Redevelopment of Sydney Fish Market

Response to Environmental Assessment Submissions

MP10_0060

December 2010

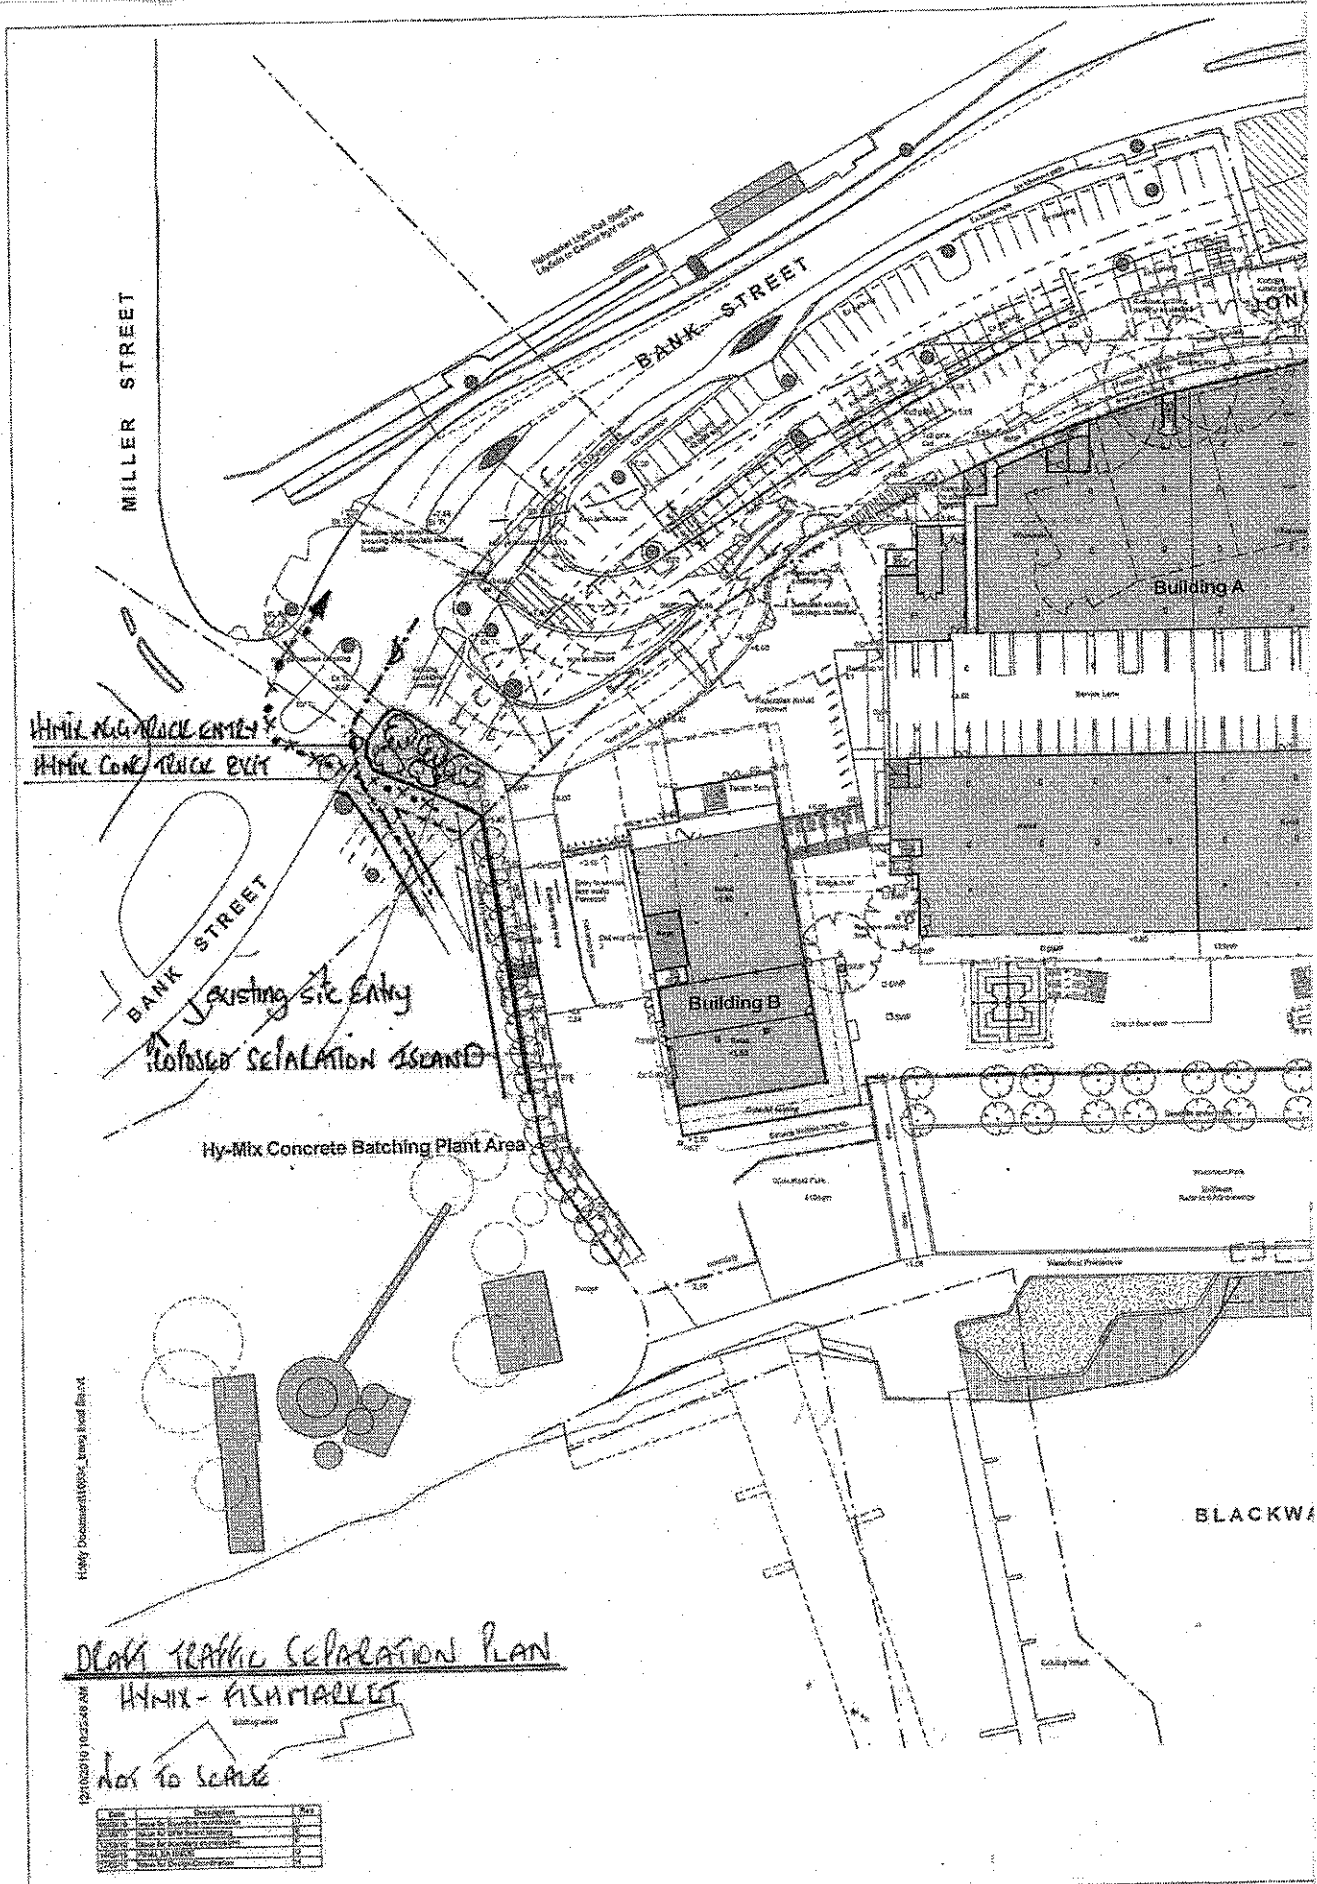
The attached draft separation sketch identifies the potential to adopt a staged approach for traffic access to both sites. Both Hymix and the Fish Market management have met and agree that this traffic separation will alleviate the current merge problems and meet the needs for future pedestrian, truck and vehicle traffic at this intersection.

- In line with the principles adopted in the attached sketch amend the access corridor from the intersection to separate vehicle movements.
- Keep pedestrian traffic flows to the Southern side of the intersection.
- Along the current Hymix boundary we feel that some form of sound attenuation wall be constructed to assist in achieving the overall ambience of the proposed development.
